## TECHNICAL MEMORANDUM

To: Sayra Molina  
Cc: Chris Marshall  
Karel Stoitchkov  
From: Anila Moorthy  
Preston Jutte, PE  
Daniel Solomon, AICP  
Date: June 3, 2022  
Subject: 301 Florida Avenue NE Comprehensive Transportation Review (ZC No. 21-26)

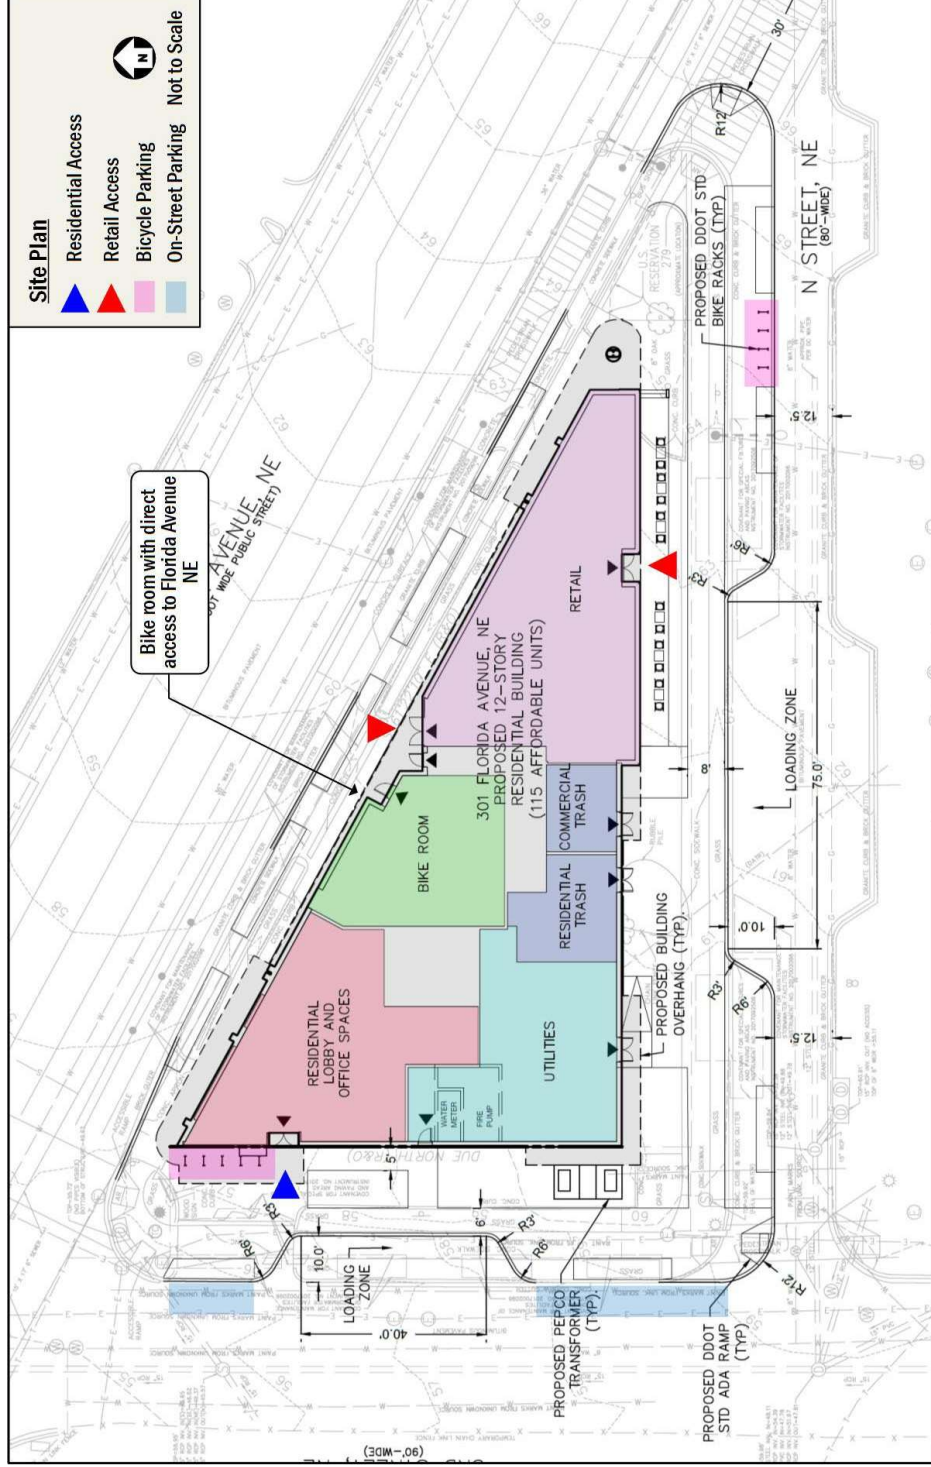
DDOT 3/27/22: There is not enough info on this graphic to provide feedback on the 3<sup>rd</sup> Street Loading Zone. We would need to see 1) where the curb lines are on both sides of 3<sup>rd</sup> Street and Street and cross-section, 2) sidewalk width on east side of 3<sup>rd</sup> Street, and 3) and location of tree boxes. DDOT could support this loading zone if it's a "recessed parking lane" rather than a layby. The different is mainly whether trees are lost. Let's continue to discuss during zoning.

GS: Added language to reflect updated site plan based on community feedback and concerns regarding loading and PUDO.
